# Work Order ID 116152

Item Name: Crosstube Turning Detail

DRAWING NO. D212-664-241	TITLE CROSSTUBE ASSY (205/212 HI AFT)	REV. D	<b>DART AEROSPACE LTD ENGINEERING ORDER</b>		D.E.O. NO. D212-664-241-D-1	SHEET NO. SHEET 1 OF 2	SCALE NTS
DRAWN	CHECKED	MFG. APPR.	APPROVED	DE APPR.			
DATE 11.04.07	DATE 11.04.11	DATE 11.04.12	DATE 11/04/12	DATE 11.04.12

DRAWING NO. D212-664-241	TITLE CROSSTUBE ASS'Y (205/212 HI AFT)	REV. D	<b>DART AEROSPACE LTD ENGINEERING ORDER</b>		D.E.O. NO. D212-664-241-D-2	SHEET NO. SHEET 1 OF 1	SCALE NTS
DRAWN <i>q</i>	CHECKED <i>ASS</i>	MFG. APPR. <i>DS</i>	APPROVED <i>MP</i>		DE APPR. <i>HA</i>		
DATE 11.07.15	DATE 11.07.20	DATE 11.07.21	DATE 11/27/21		DATE 11.07.21

**D212-664-241/-241B  
ASSEMBLY DETAIL**

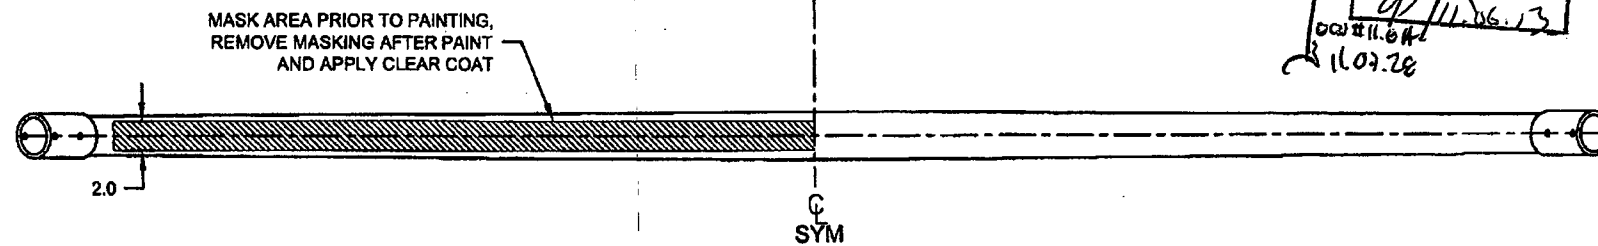
**PURPOSE:**

ADD AN INSPECTION WINDOW TO UNDERSIDE OF CROSSTUBE.

NOTES 2 OF SHEET 1 IS AMENDED AS FOLLOWS:

- 2) FINISH: CHEMICAL CONVERSION COAT PER DART QSI 005 4.1  
PRIME INSIDE AND OUTSIDE PER DART QSI 005 4.2  
MASK UNDERSIDE OF CROSSTUBE AS SHOWN (HATCHED AREA) AND  
PAINT OUTSIDE PER DART QSI 005 4.2  
REMOVE MASKING AND APPLY CLEAR COAT

- 2) FINISH: CHEMICAL CONVERSION COAT PER DART QSI 005 4.1  
PRIME INSIDE AND OUTSIDE PER DART QSI 005 4.2  
PAINT OUTSIDE PER DART QSI 005 4.2
